Nature of Project: WAYNFLETE ARTS CENTER, PHASE TWO

**date:** November 29, 2007  
**project:** WAYNFLETE ARTS CENTER, PHASE TWO, 2003-0040  
**re:** Mike Nugent questions of November 24, 2007.  
**to:** Mike Nugent City of Portland

Below are questions proposed by Mike Nugent, consulting Plans Examiner, City of Portland in an e-mail on November 24, 2007. **Responses by Scott Simons Architects are noted in Bold**

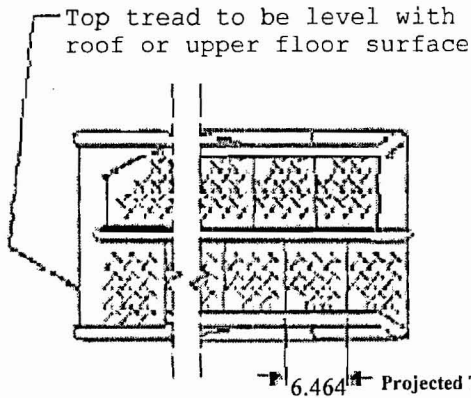
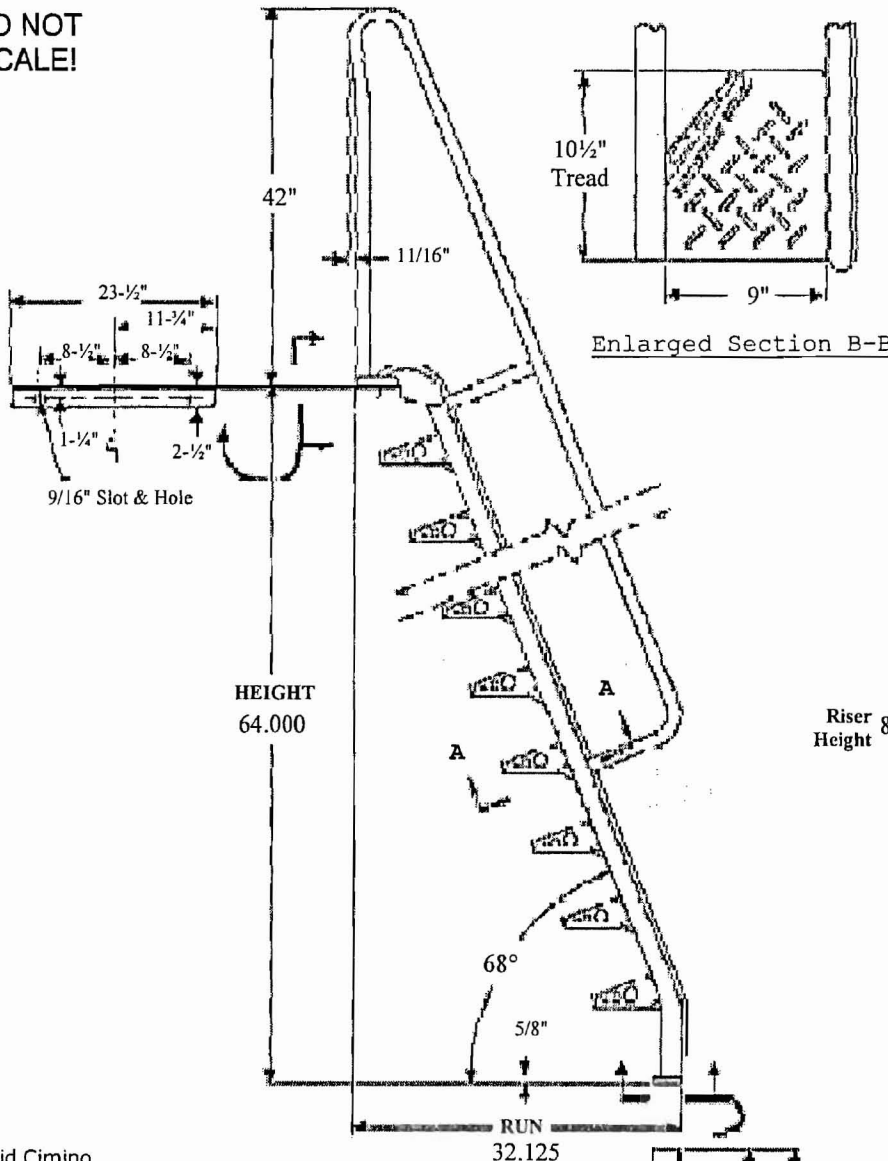
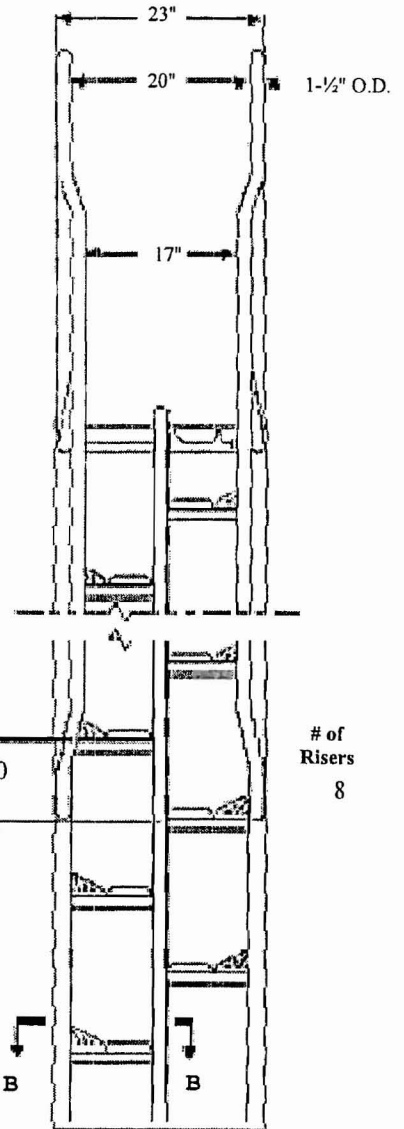
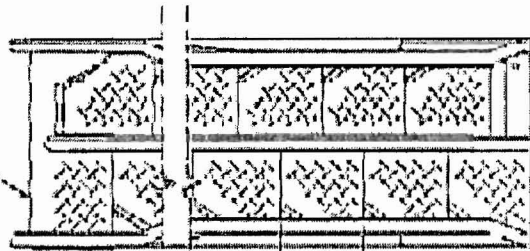
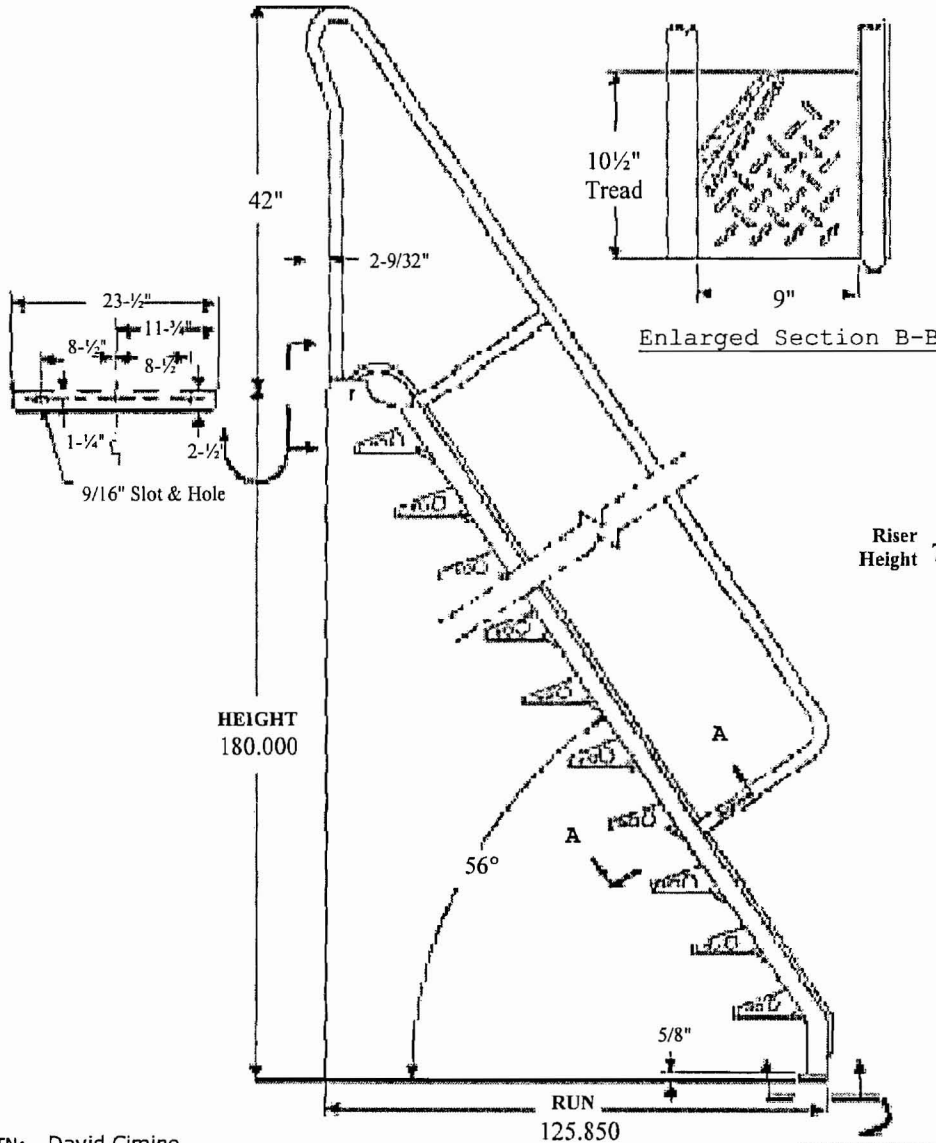
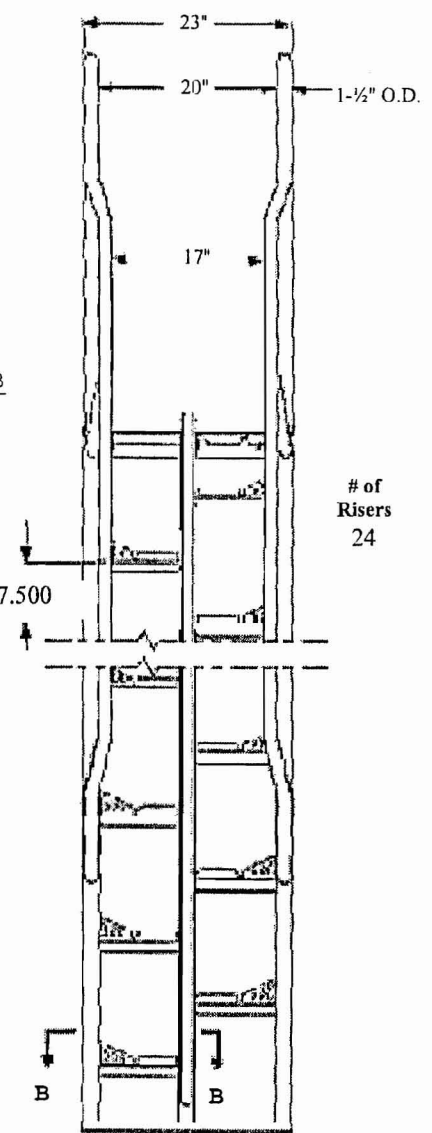
6) Please provide specs for the alternating tread stairs that establishes compliance with all elements of section 1009.10.
